**EMERGENCY DROUGHT APPLICATION: GROUNDWATER REVIEW**

SUBJECT: Application G- 19085  Re-review; date of original review: ##/##/####

Applicant’s Name: Cory Turner County: Klamath

A1. Applicant(s) seek(s) 9.0 cfs from 3 well(s) in the Klamath Basin  
Lost River – Tule Lake Subbasin

**Hydrographs for Area Wells**

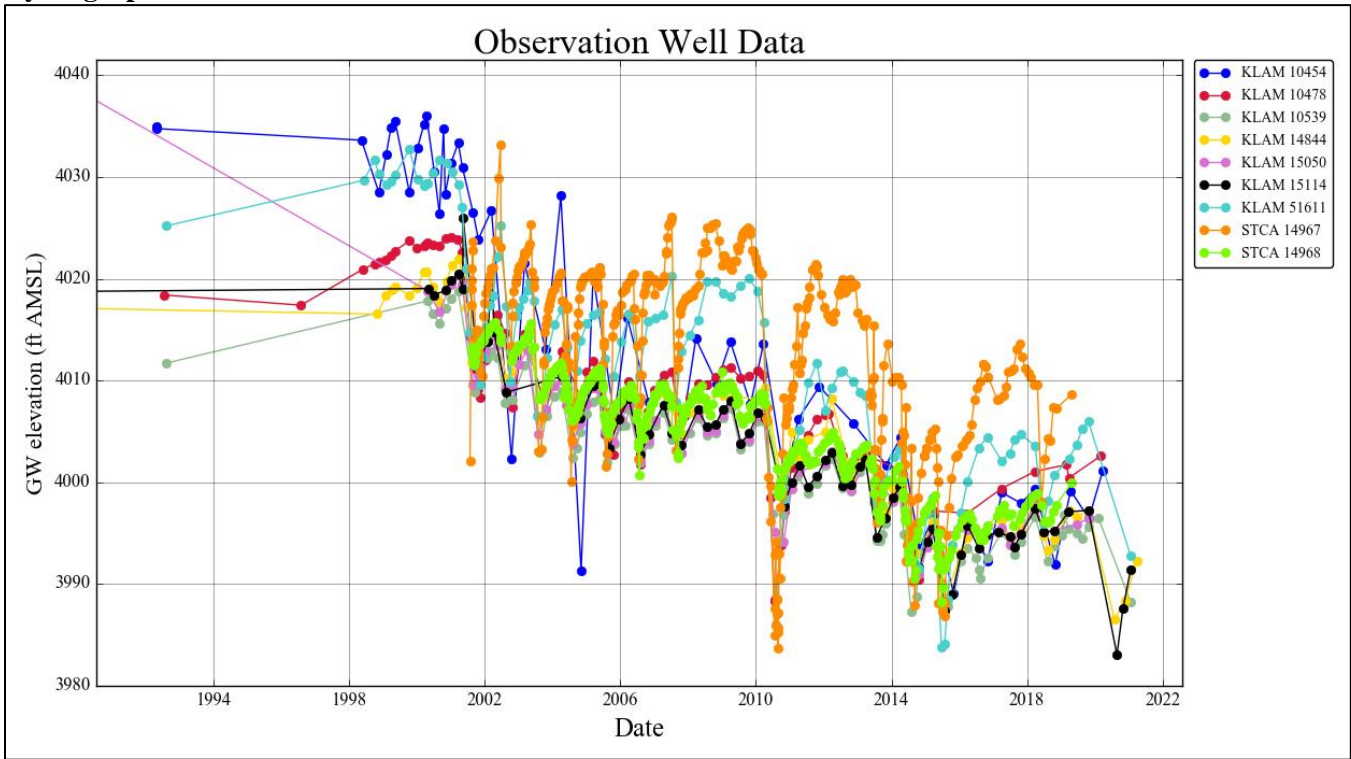
Seasonal groundwater level fluctuations in response to pumping in this area are generally on the order of 10-20 feet and most wells on groundwater rights are deep enough to accommodate this seasonal interference. However, long-term groundwater level declines have been documented throughout the area and are punctuated by drought-related groundwater pumping. Pumping related to 2021 emergency drought use by this, and other wells, is expected to exacerbate these declines, which has the potential to impact shallow wells.

Groundwater levels have declined noticeably across almost the entire Lost River Subbasin within the past 20 years and over 20 feet in some areas implying that the groundwater resource is over-appropriated as defined in OAR 690-400-0010. Increased use by drought-permit wells and supplemental groundwater rights are anticipated to continue these declines.
